**SUBDIVISION,  
PLANNED UNIT DEVELOPMENT,  
PLANNING APPROVAL &  
ZONING AMENDMENT STAFF REPORT**

**Date: January 7, 2021**

St. Mary Catholic School Subdivision

REQUEST Subdivision, PUD, PA, Rezoning from B-1 to R-1

## DETAIL SITE PLAN

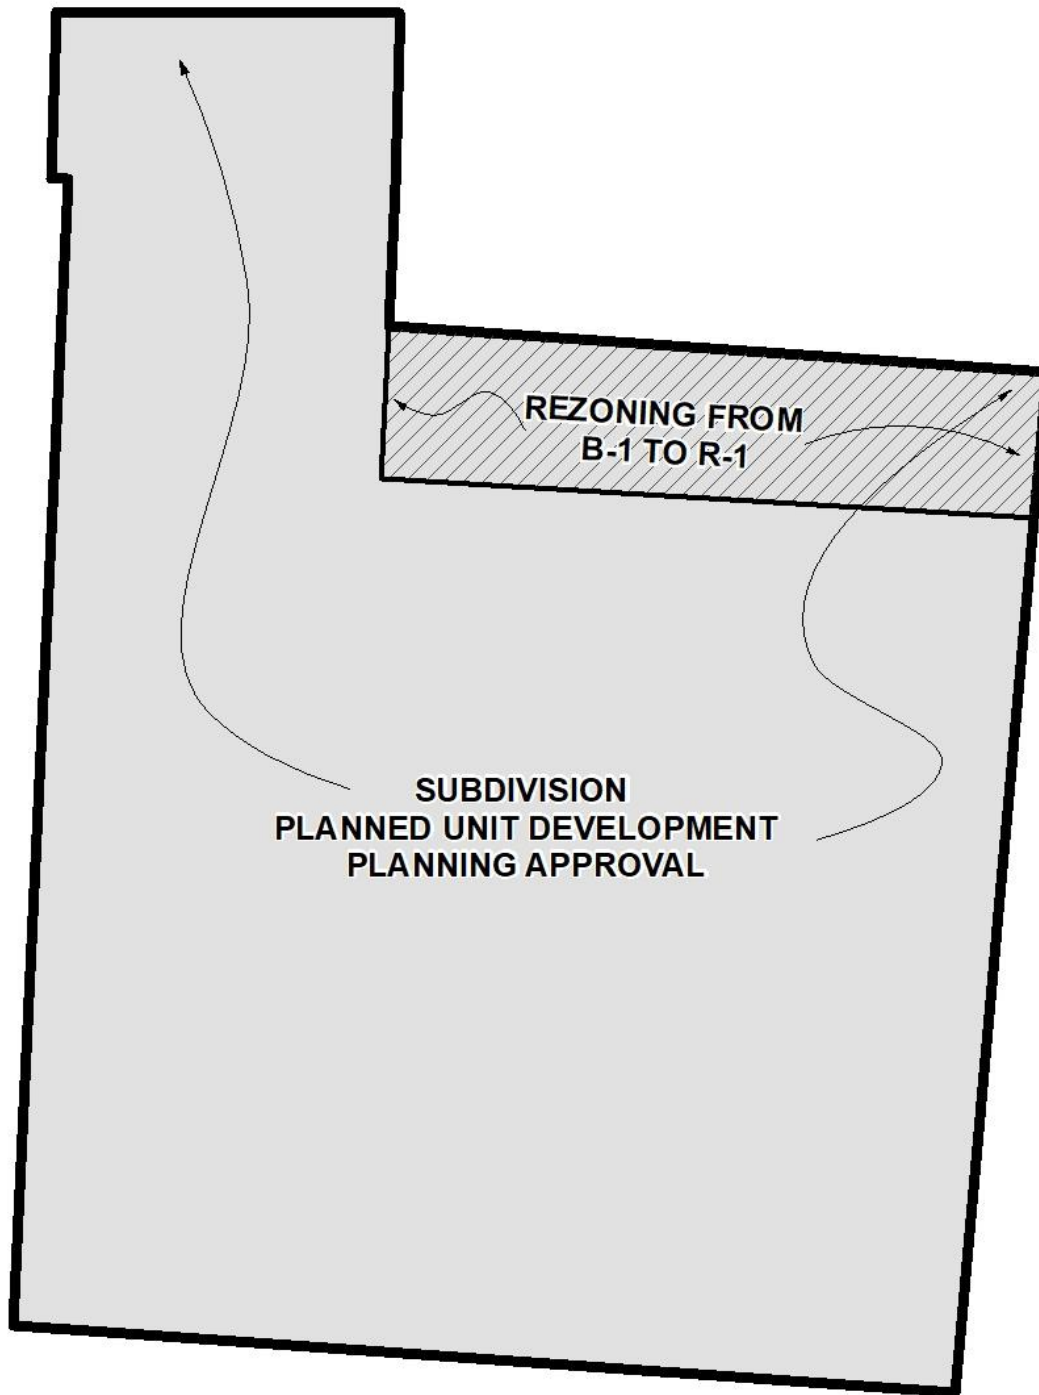
The PUD addresses the multiple structures on the proposed single lot. The site plan indicates the existing school buildings, two existing dwelling buildings and the proposed pavilion building. Calculations on the site plan indicate compliance with the landscaping requirements of the Zoning Ordinance, and a note states that compliance with both the landscaping and tree planting requirements will be indicated on the site plan submitted for project construction. The site plan

indicates that 87 parking spaces are provided on site, but does not provide the calculations for such, nor does it provide any information on the proposed use of the two dwellings being added to the site or the parking required for their use. Therefore, the site plan should be revised to provide parking calculations for all buildings and proposed uses on the over-all site.

Pertaining to the proposed pavilion, the indicated setback off the Providence Street right-of-way is 21', which would not meet the normal minimum 25' building setback. As previously stated, since the site is within a historic district, setbacks would be governed by Section 64-3.G. Historic District Overlay requirements of the Zoning Ordinance. Therefore, the proposed setback off Providence Street appears to be in order. However, the distance from the Northeast corner of the pavilion to the adjacent R-1 property to the North is not provided and should be at least ten feet. Therefore, the site plan should be revised to indicate the pavilion would meet the ten-foot setback requirement off the R-1 property to the North.

The site abuts R-1 properties to the North. As no residential buffer is indicated on the site plan, it should be revised to provide a residential buffer, in compliance with Section 64-4.D.1. of the Zoning Ordinance. The site plan indicates a dumpster is to be provided, and public sidewalks currently exist along all street frontages. The site plan indicates gates at the Old Shell Road and Providence Street entrances to the site. Therefore, a note should be required on the site plan stating that those gates are to remain open during the hours of operation of all school-related activities.

- 1) *retention of the parking and landscaping calculations on a revised site plan;*
- 2) *revision of the site plan to indicate the site configuration after all dedications required by the Subdivision;*

- 3) *revision of the lot size label to reflect any required dedications, or the furnishing of a table on the site plan providing the same information;*

- 5) *provision of a residential buffer, in compliance with Section 64-4.D.1. of the Zoning Ordinance, where the site abuts residential properties, as indicated on the site plan;*
